SUNDRY NOTICES AND REPORTS ON WELLS
Do not use this form for proposals to drill or to re-enter an abandoned well. Use Form 3160-3 (APD) for such proposals.

Dome Federal 24 #21

PLUG AND ABANDONMENT PROCEDURE

CONDITIONS OF APPROVAL

Proposed P&A

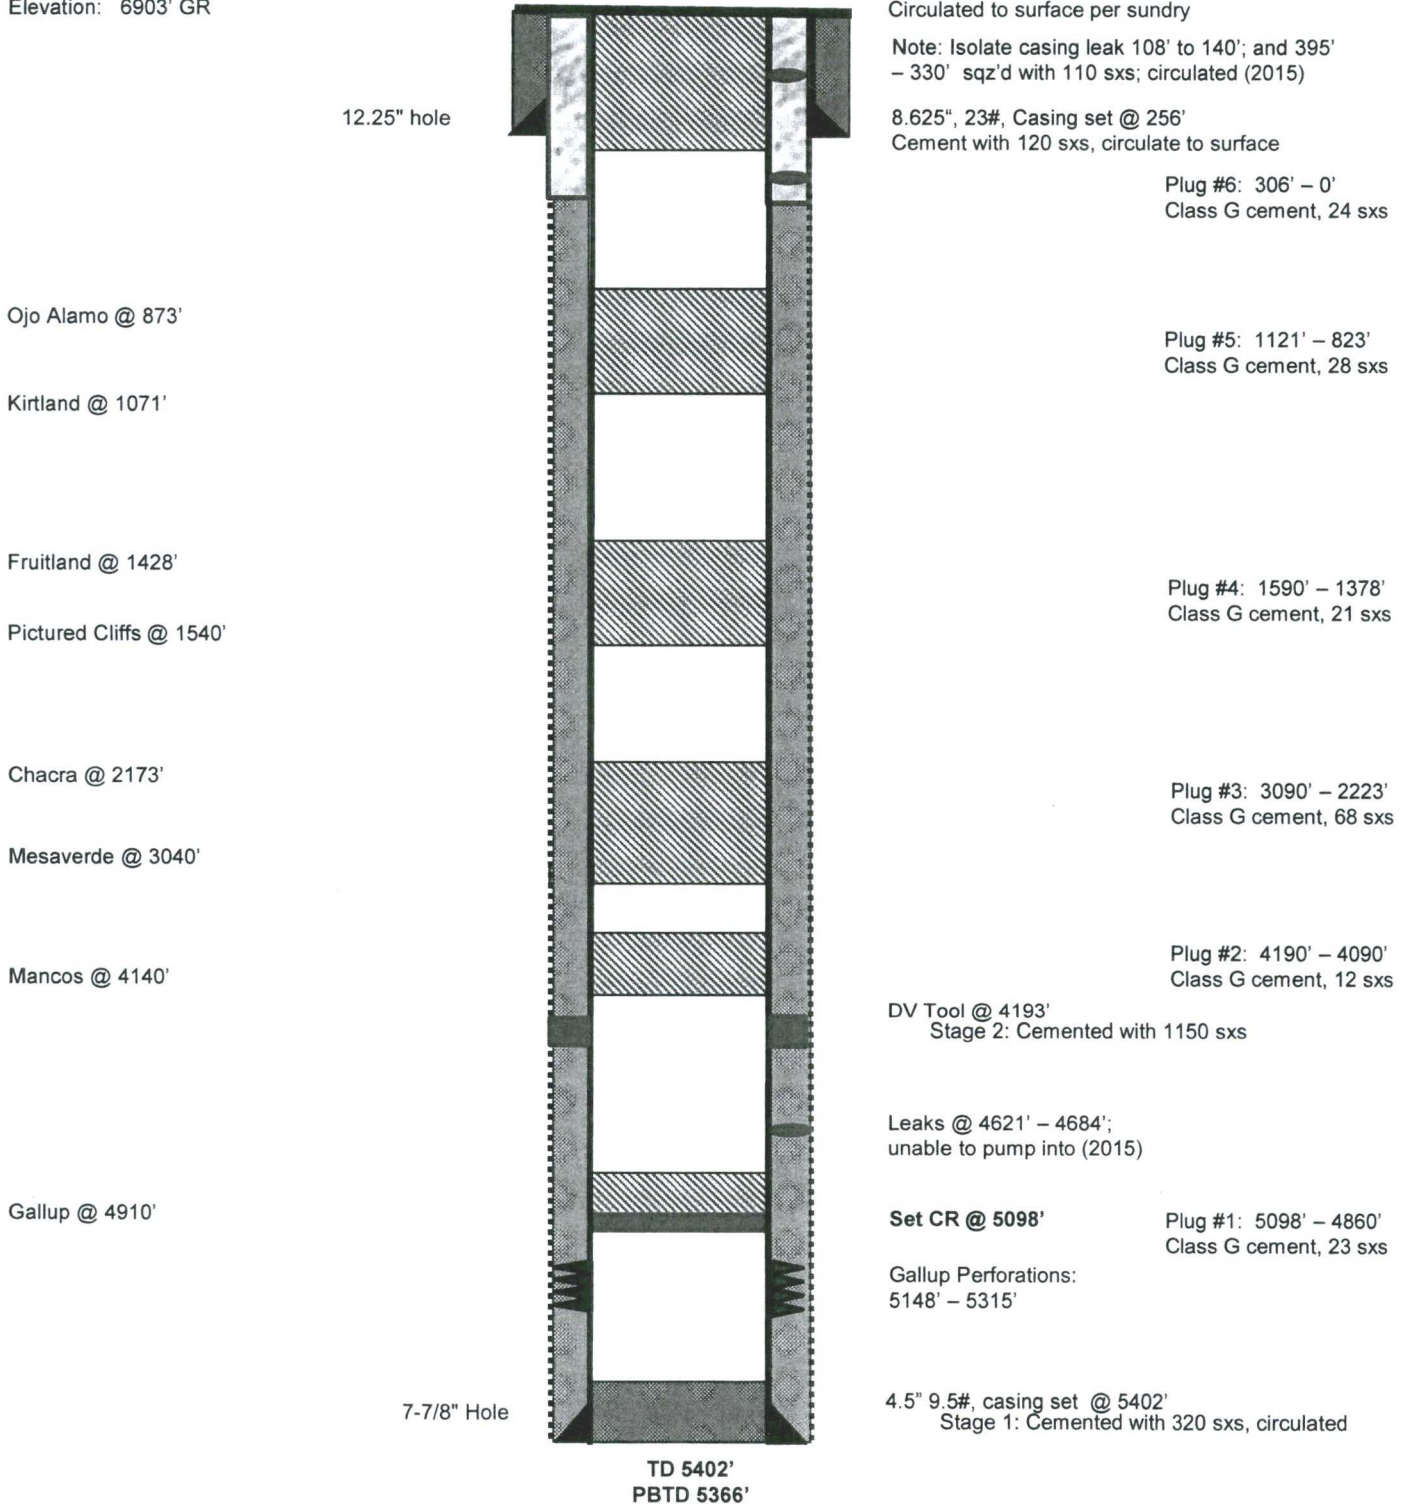
- a) Set plug #3 (2410 - 1907~~5~~) ft. to cover the Mesaverde and Chacra tops. BLM picks top of Mesaverde at 2360 ft. BLM picks top of Chara at 1957 ft.
- b) Set plug #4 (1640 - 1388) ft. to cover the PC and Fruitland tops. BLM picks top of Pictured Cliffs at 1590 ft. BLM picks top of Fruitland at 1438 ft.
- c) Set plug #5 (1185 - 900) ft. to cover the Kirtland and Ojo Alamo tops. BLM picks top of Kirtland at 1135 ft. BLM picks top of Ojo Alamo at 950 ft.
